REQUEST FOR INFORMATION

Job Name: Harrison **Job #** 24035 **RFI #** **Date:** 11/26/2024

| STRUCTURE | HARRISON RECREATION & COMMUNITY CENTER | |
| DRAWING TITLE: | ANCHOR BOLT PLAN | |

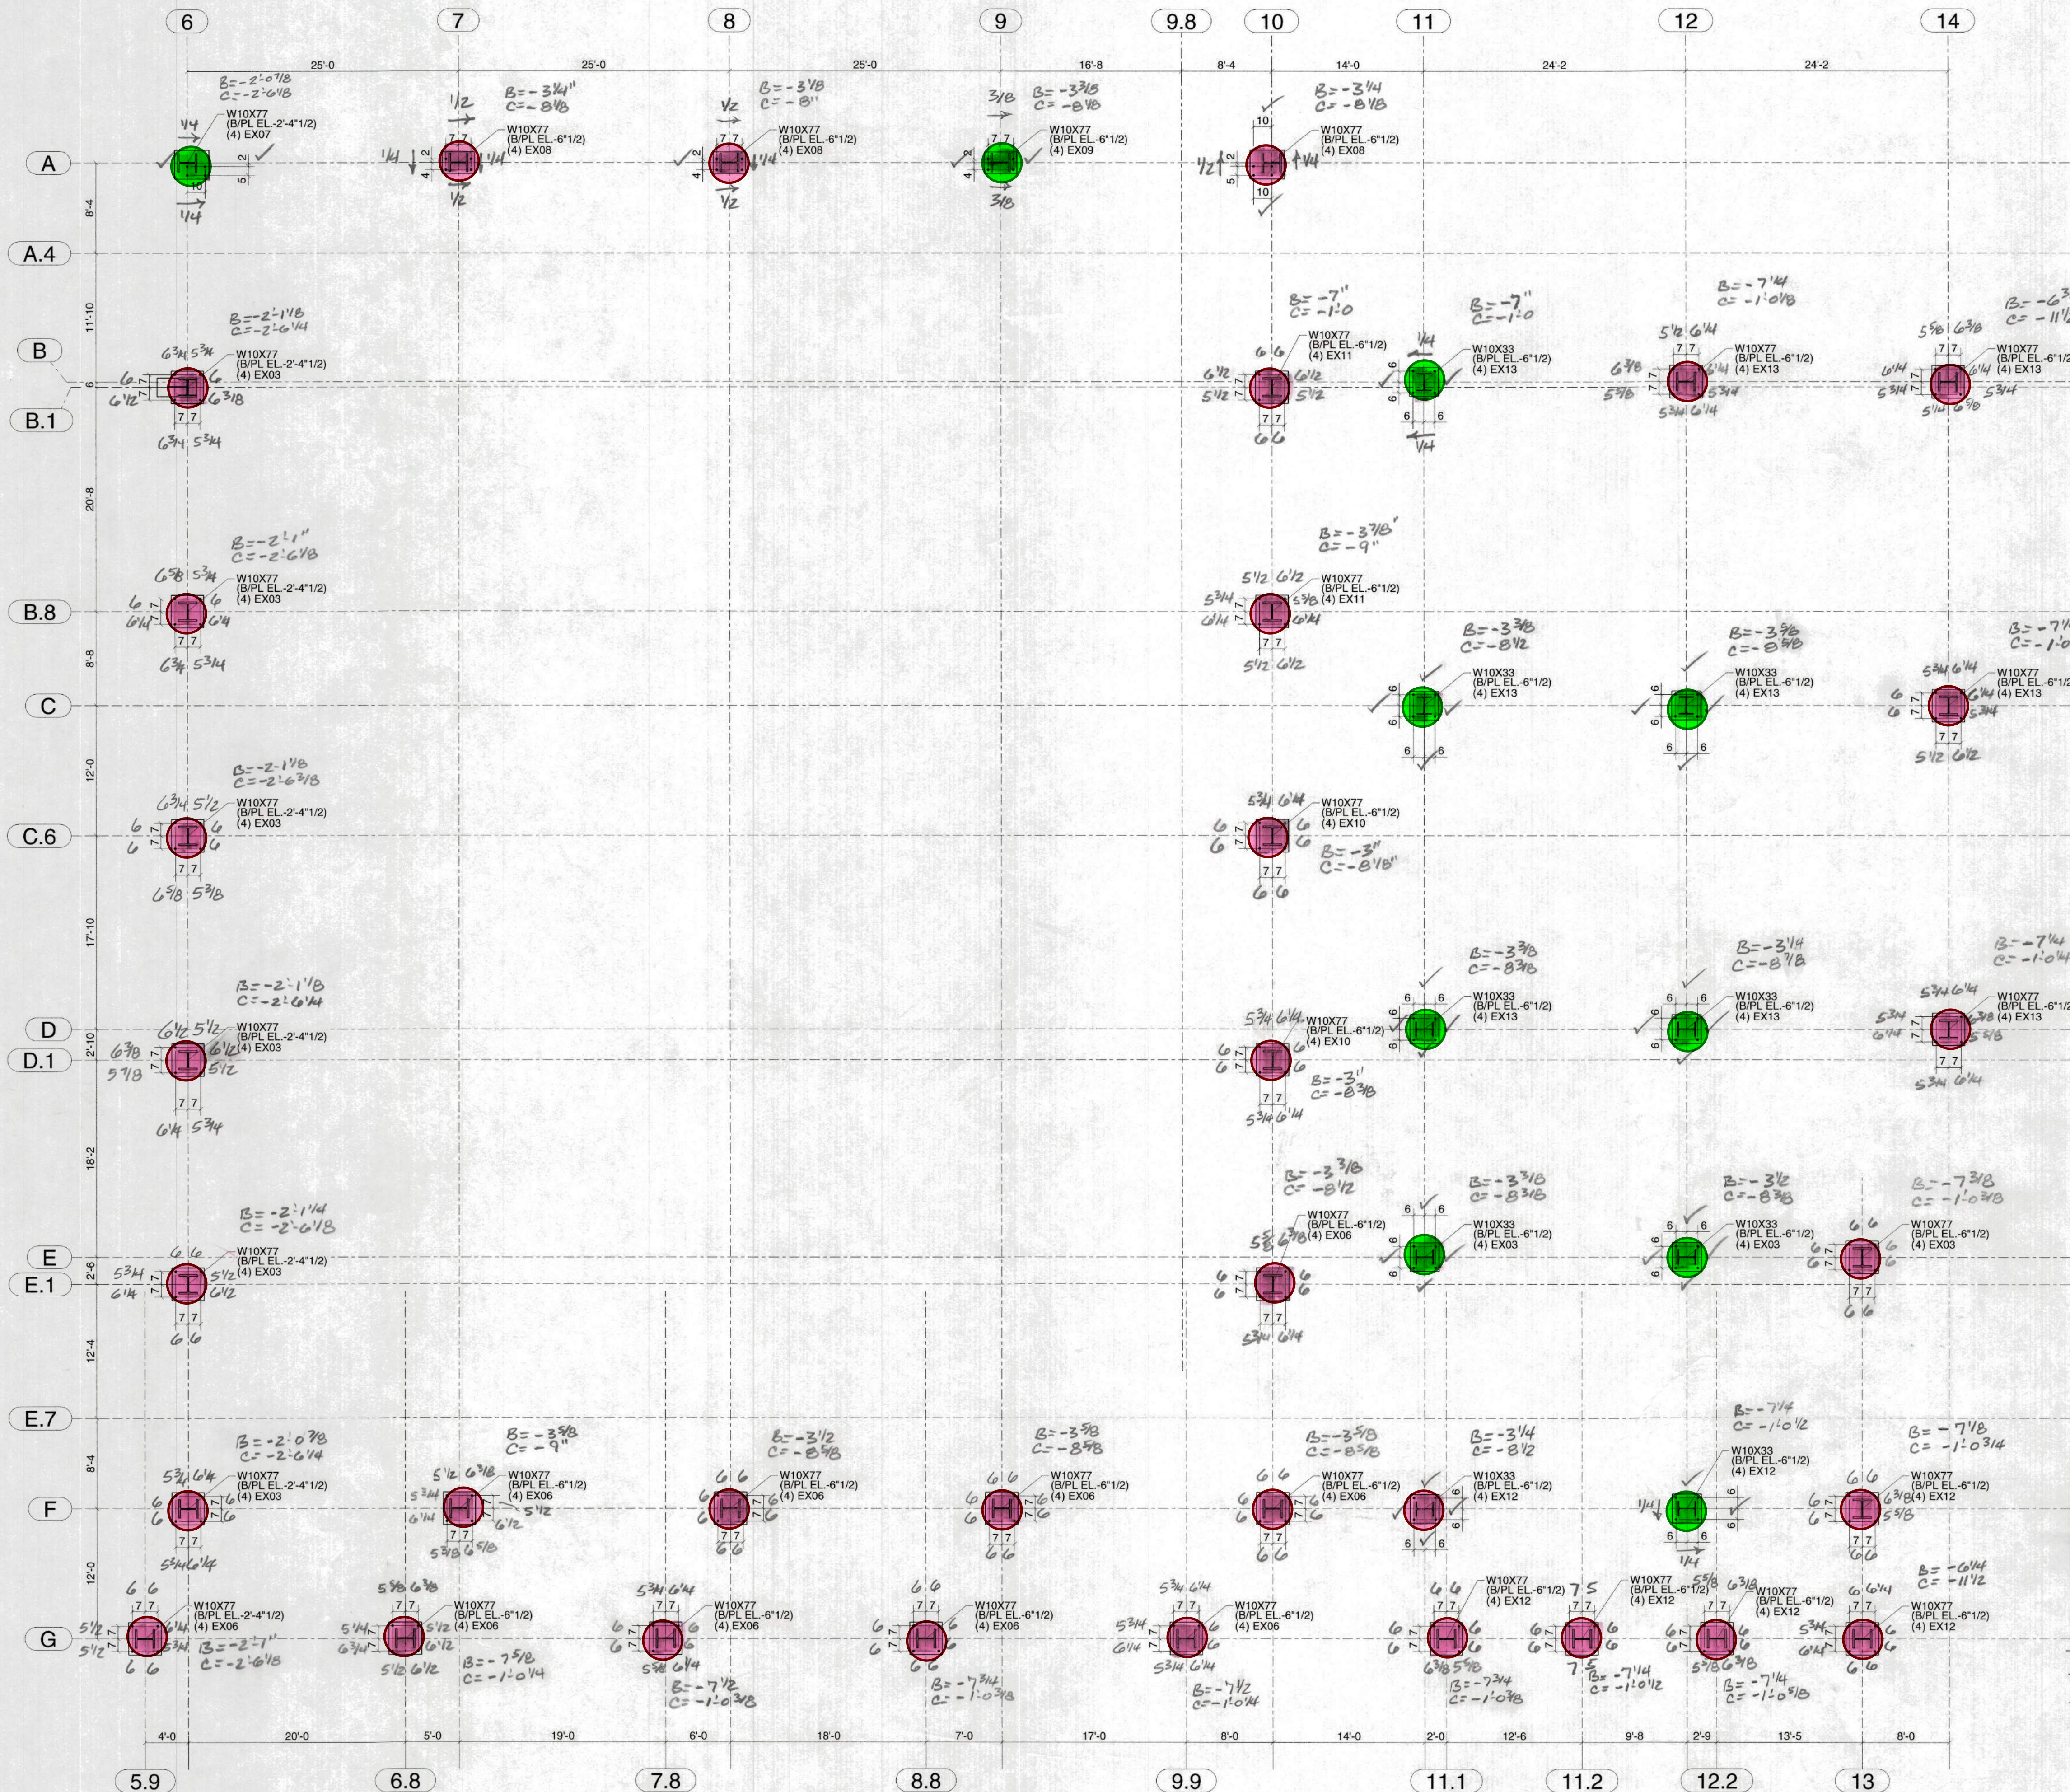
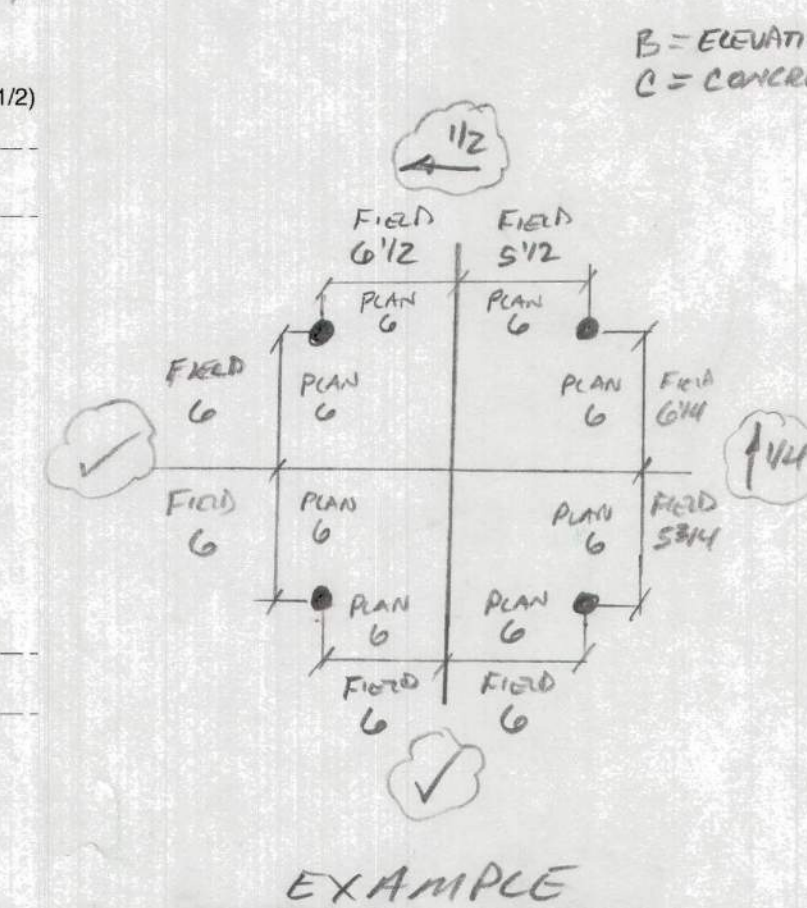
Question: #1 The AB Pattern for the W10 columns is extremely tight and does not allow for clearance between the weld and plate washer. Please see attached details and advise if alternate weld & PL Washer details can be developed.

We noted in our anchor bolt shop drawings that the bolt spread on the baseplates under the W10x77 columns needed to be increased due to a fouling. In a perfect world, there was exactly 1/8" clearance between the plate washer and the column flange, which didn't even leave room for the welding of the column to the baseplate. With these cast in place anchors already being installed, they will not work and will cause numerous columns to foul on the anchor bolts.

Not sure what the course of action is for these, since they were poured under a different contract, but there are 73 total anchor bolt groups, and only 12 of them have anchor bolts within tolerance and are usable. The other 61 groups are unusable.

Answer #1 Alternate welds and details will be acceptable. Based on previous coordination meeting with the architect, SER, GC, and manufacturer revised details will be included in the revised shop drawing package.

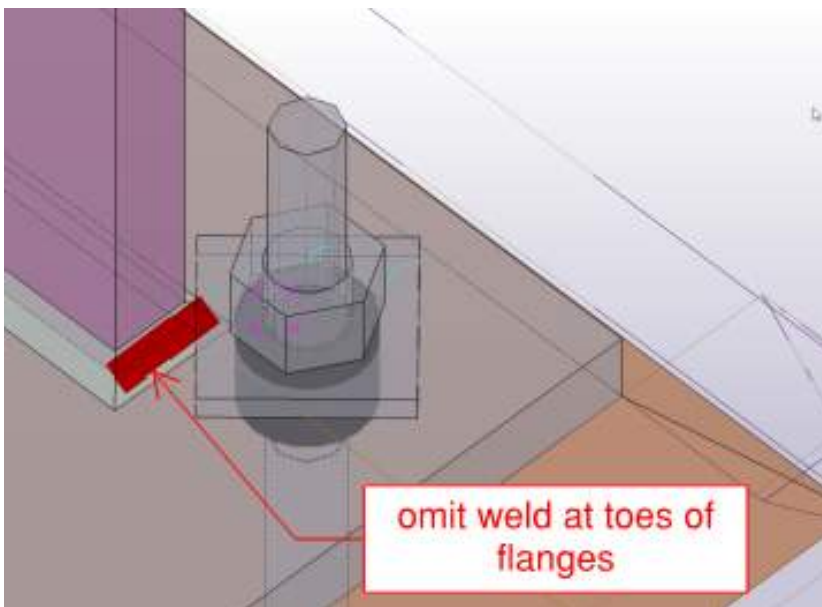
See below if we omit the weld at the toe of flange, we should be able to just make it. this would be ideal conditions obviously if there are other deviations that might complicate things. Maybe we can also look to reduce PL Washer size as needed as well.

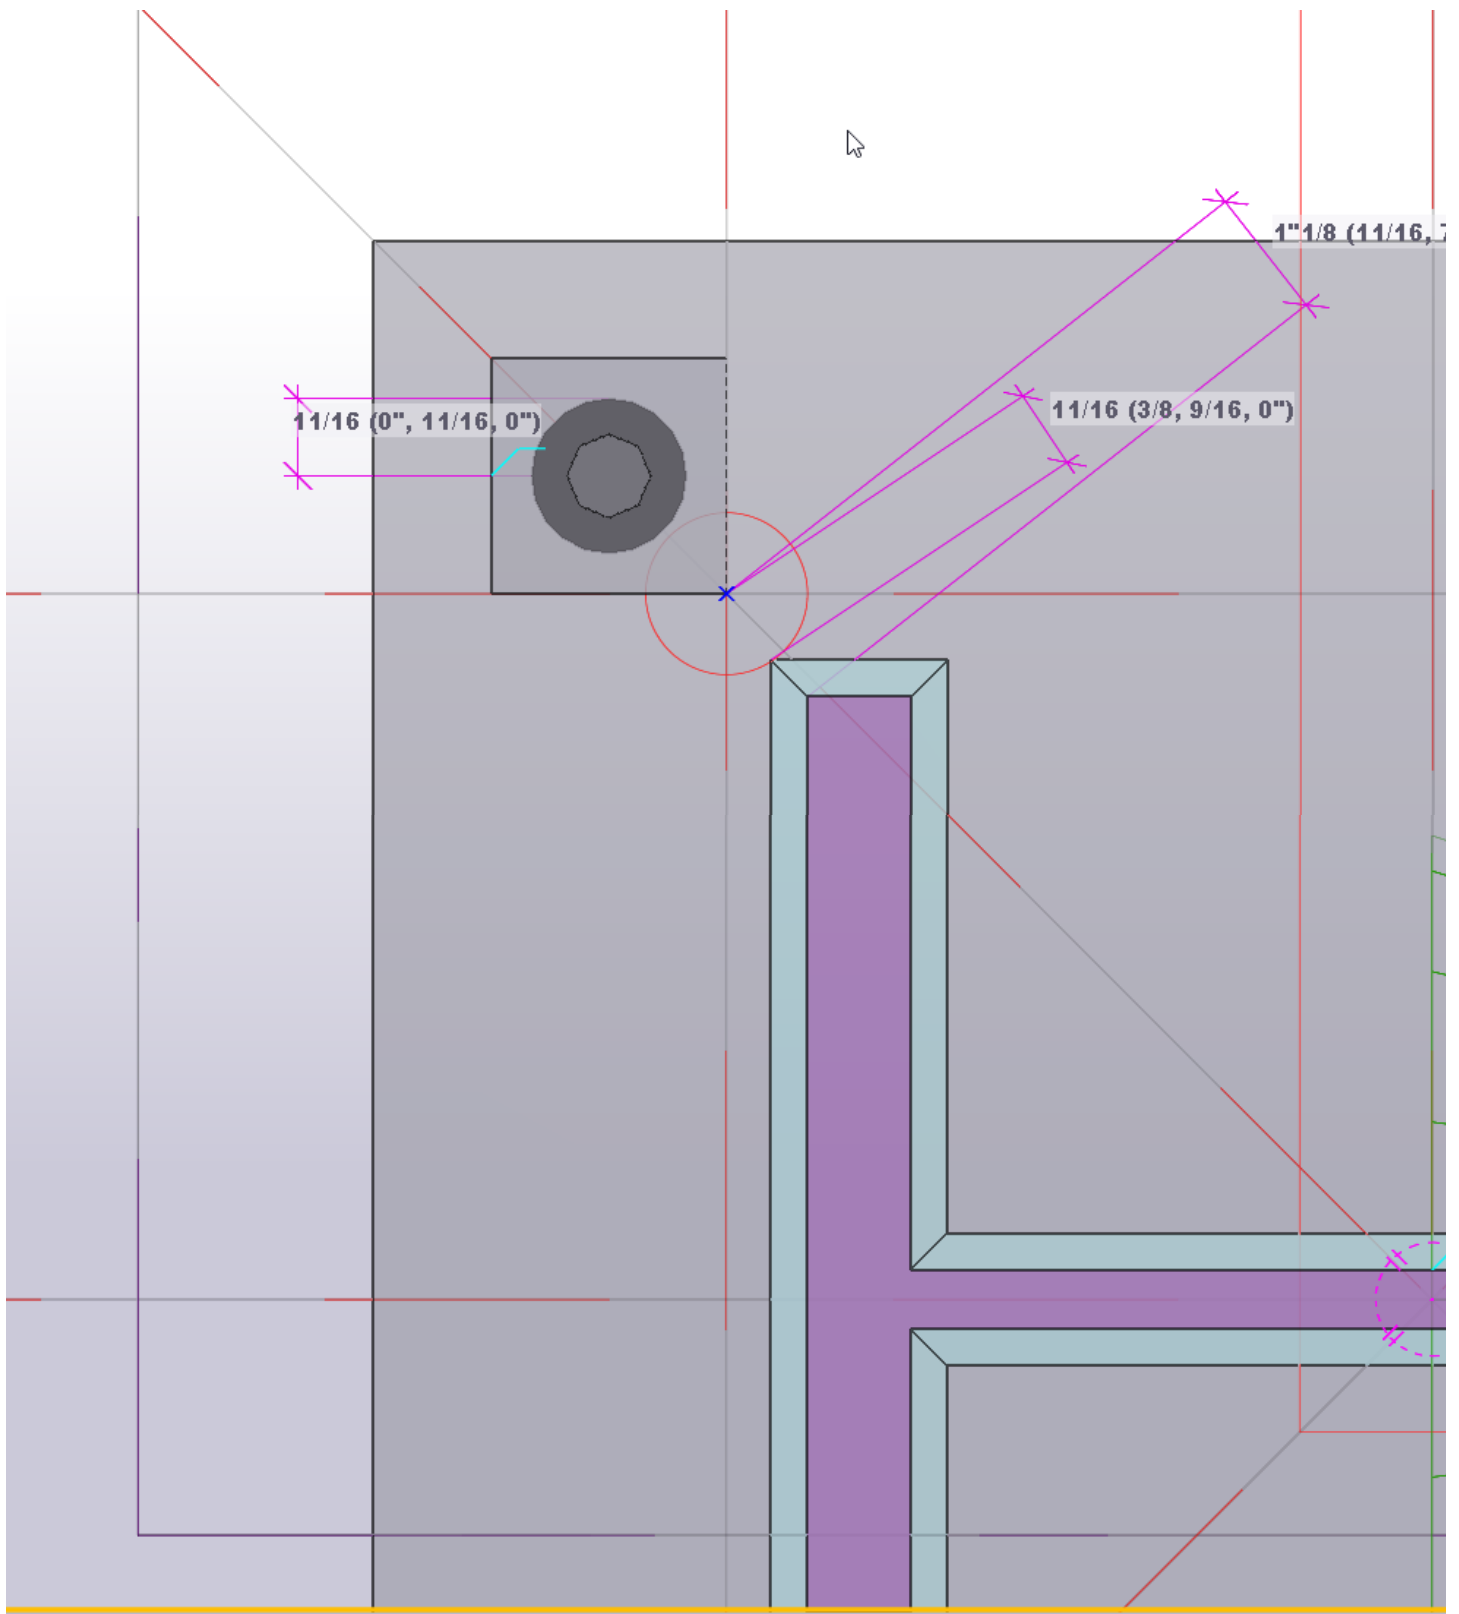
I asked our detailers to send the below over so you can better see the issue:

Red circle is at 6" spread

Red circle is the diameter of the nut

11/16 away from the edge of the weld

1 1/8" away from toe of flange
